**Advisory Action  
Before the Filing of an Appeal Brief**

10/726,298

MICHELITSCH ET AL.

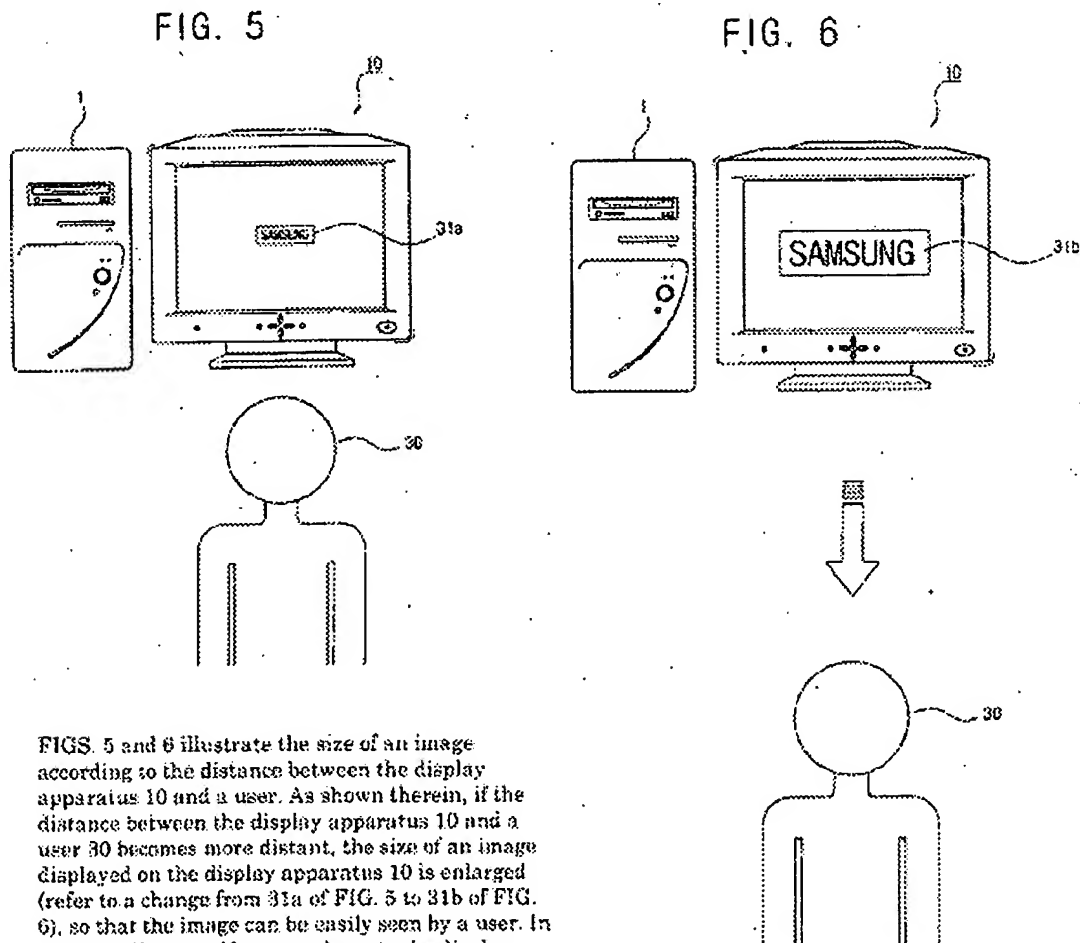
Applicant's remarks (filed 11/19/2007) are directed to limitations that are not included in the rejected claims. For example, the phrase "amount of text" in claim 16 is not limited to the number of characters in a string of letters used to represent display information. Instead, the "amount of text" can exclusively describe the volume or portion of the screen it occupies, especially when the first amount is claimed as being "larger". Lee taught this feature, see figures 5 and 6, reproduced below:

FIGS. 5 and 6 illustrate the size of an image according to the distance between the display apparatus 10 and a user. As shown therein, if the distance between the display apparatus 10 and a user 30 becomes more distant, the size of an image displayed on the display apparatus 10 is enlarged (refer to a change from 31a of FIG. 5 to 31b of FIG. 6), so that the image can be easily seen by a user. In contrast, if a user 30 moves closer to the display apparatus 10, the size of the image displayed on the display apparatus 10 is reduced. (Lee, para. [0038]).
